VENDOR SERVICE PUBLICATION

SUBJECT: Oil Pump Impeller and Drive Replacement; AVCO Lycoming Service Bulletin No. 385C dated October 3, 1975 (attached).

Service Bulletin

Service Bulletin No. 385C
(Supersedes Service Bulletin No. 385B)
Engineering Aspects are
FAA (DEER) Approved

Figure 1. Interior View of Accessory Housing Showing Location of Cotter Pin in Oil Pump Idler Shaft

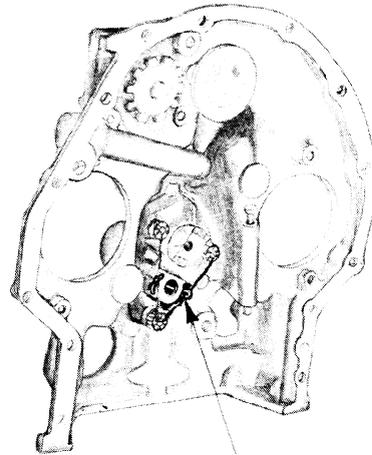
INSPECTION: Applicable remanufactured engines shipped after December 21, 1972 should be inspected to determine if this modification is required: first of all, if the engine log book indicates the engine has not been modified in accordance with Service Instruction No. 1230 or No. 1272, proceed to remove the accessory drive cover from the mounting pad at the lower right side of the accessory housing to obtain access to the area between the crankcase and the accessory housing. On some engines this accessory drive pad is not machined, in this event it will be necessary to remove either the left magneto or the *fuel pump to obtain access to the area between the crankcase and the accessory housing. Regardless of which accessory pad is used, determine if the oil pump idler gear is secured with a cotter pin at the location shown in figure 1. This can be accomplished using an inspection mirror, preferably an illuminated one. If the cotter pin is visible, it is unnecessary to perform the modification required by this bulletin.

IF IDLER SHAFT IS SECURED WITH A COTTER PIN AT THIS LOCATION MODIFICATION IS NOT REQUIRED

Figure 2. Oil Pump Drive Assembly

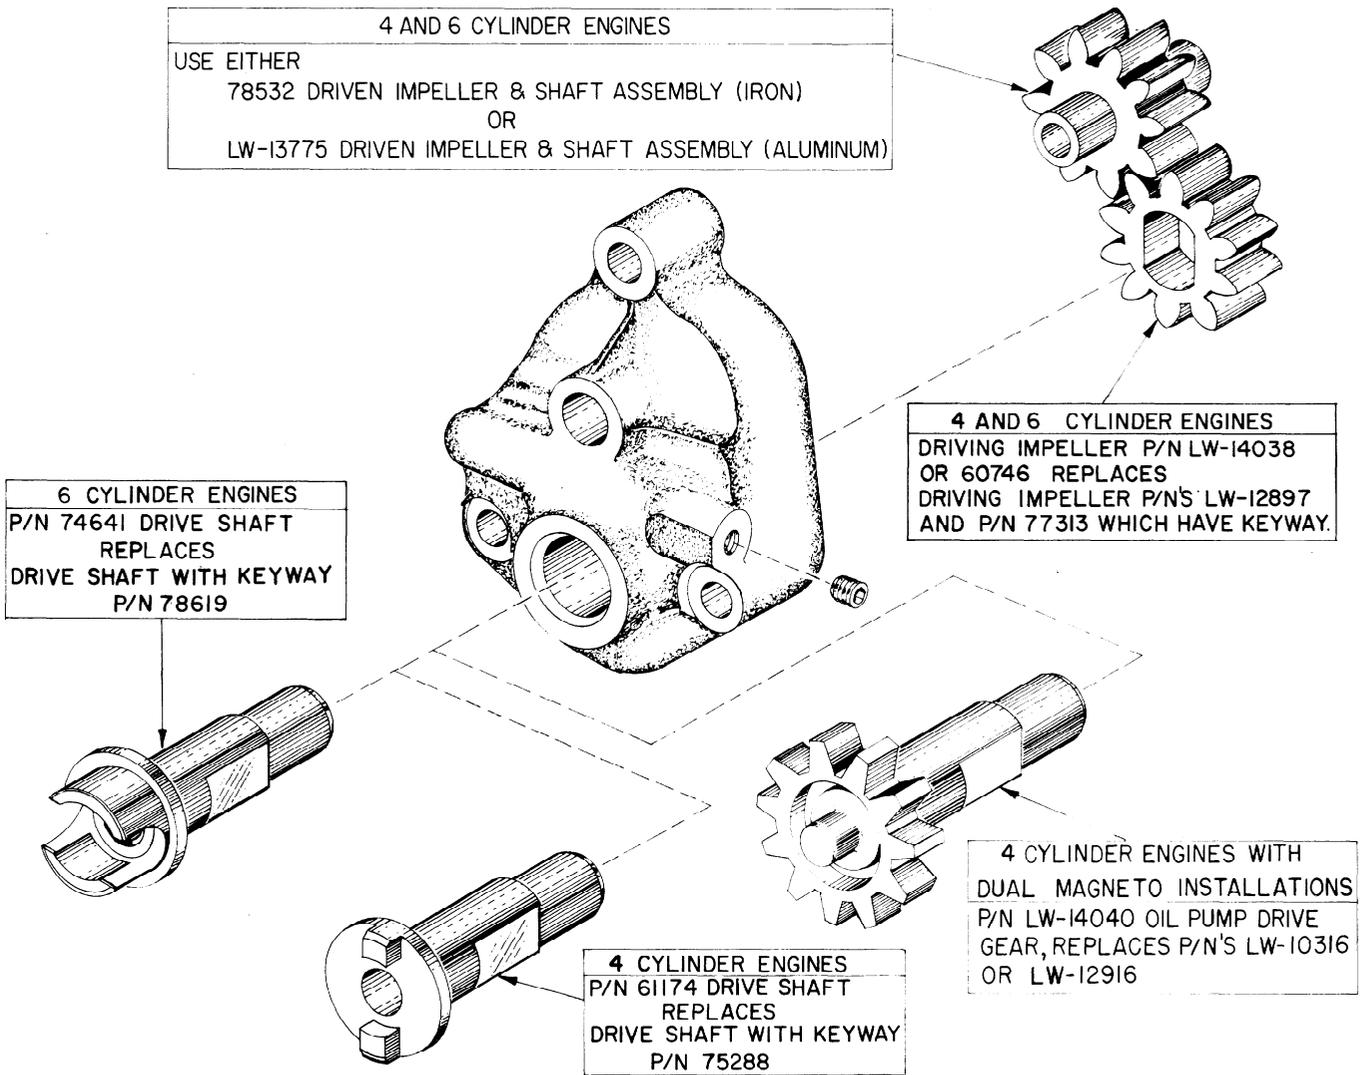
This modification consists of replacing the oil pump drive shaft and drive impeller to eliminate the Woodruff key drive which has proven to be the cause of excessive wear in the keyway of the hardened drive impeller. Therefore, it is recommended that all of the applicable engines listed in the chart, as well as any others that may have been modified in accordance with Service Instruction No. 1272, use the following procedure for parts replacement.

3. Reassemble the oil pump using the new drive shaft and drive impeller supplied with the kits shown in the following "Parts Data" section. See figure 2. Be sure all of the parts are lubricated thoroughly during assembly.

- LW-14131 Oil Pump Shaft Replacement Kit (4 cylinder engines)
consists of: (1) 61174 oil pump drive shaft, (1) LW-14038 or 60746 drive impeller

- LW-14132 Oil Pump Shaft Replacement Kit (4 cylinder, dual drive magneto engines)
consists of: (1) LW-14040 oil pump drive gear, (1) LW-14038 or 60746 drive impeller

- LW-14133 Oil Pump Shaft Replacement Kit (6 cylinder engines)
consists of: (1) 74641 oil pump drive shaft, (1) LW-14038 or 60746 drive impeller
